[Docket No. FAA-2015-7527; Directorate Identifier 2015-NM-094-AD; Amendment 39-18686; AD 2016-21-05]

Airworthiness Directives; The Boeing Company Airplanes

ACTION: Final rule.

2016–21–05 The Boeing Company:
Amendment 39–18686; Docket No. FAA–2015–7527; Directorate Identifier 2015–NM–094–AD.

Figure 1 to paragraph (h) of this AD: Wiring Installation - Right Engine Fuel Spar Valve

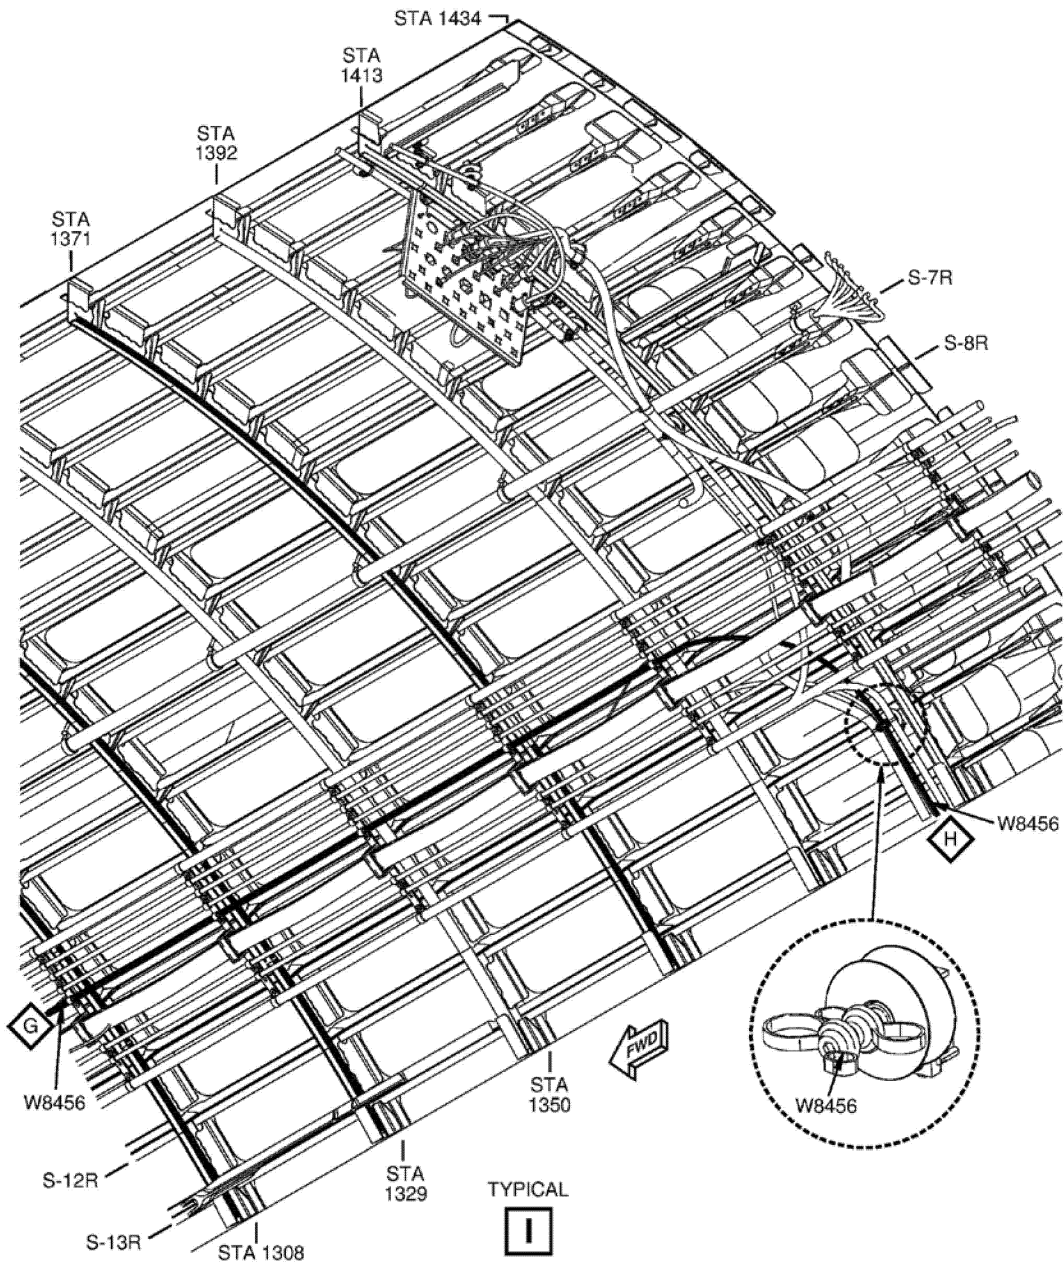
appropriate source of service information in this AD because it is not an FAA-approved document. However, we acknowledge that for certain airplanes, Figure 22, Sheet 9, of Boeing Special Attention Service Bulletin 777-28-0061, Revision 2, dated May 4, 2015, includes an editorial error, which shows incorrect wire routing. Boeing Service Bulletin Information Notice 777-28-0061, IN 03, dated November 16, 2015, allows for a modification of Group 2 airplanes that meets the requirements of the AD without an additional burden to operators. We have included a corrected figure in paragraph (h) of this AD to address this issue.

(1) Where Boeing Special Attention Service Bulletin 777–28–0061, Revision 2, dated May 4, 2015, specifies to use Figure 22, Sheet 9, for the wiring installation of the right engine fuel spar valve, this AD requires using figure 1 to paragraph (h) of this AD.
